# Wisconsin Department of Transportation

**Proposal #13: 1706-00-70, WISC 2021375**  
**Dubuque – Shullsburg**  
**.3 Mi E STH 35 to V Hazel Green**  
**STH 11**  
**Grant County**

This is Addendum No. 02, which provides for the following:

**ADDENDUM NO. 02**

Addendum No. 02  
ID 1706-00-70  
Revised Sheet 21  
June 7, 2021

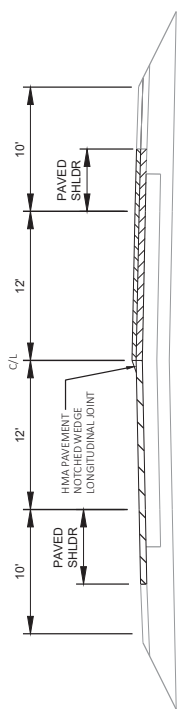
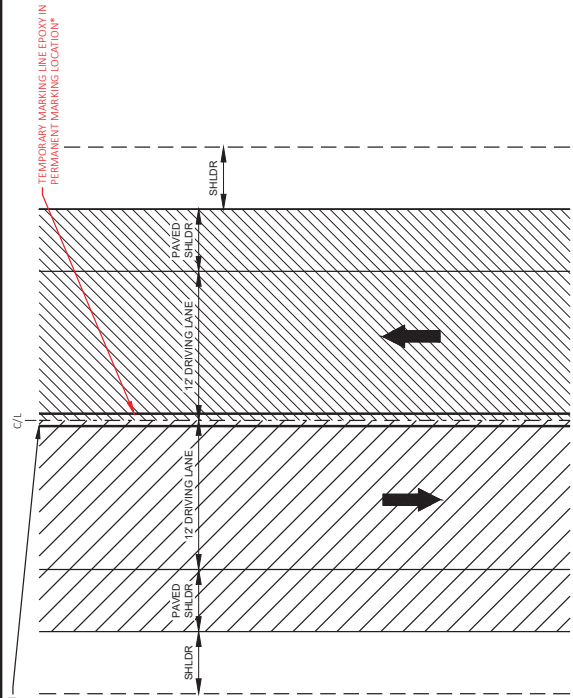
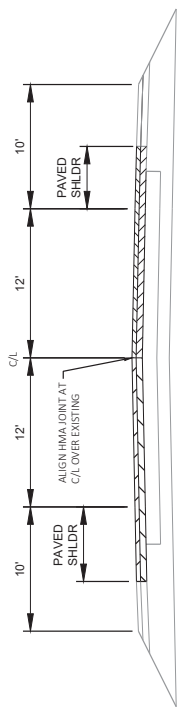
Revised Plan Sheets	
Plan Sheet	Plan Sheet Title (brief description of changes to sheet)
21	Construction Detail (Pavement marking operation to final lift of asphalt)
70	Miscellaneous Quantities (Revisions of temporary and permanent marking items)

\* TEMPORARY MARKING LINE EPOXY APPLIED SAME DAY AS FOURTH PASS
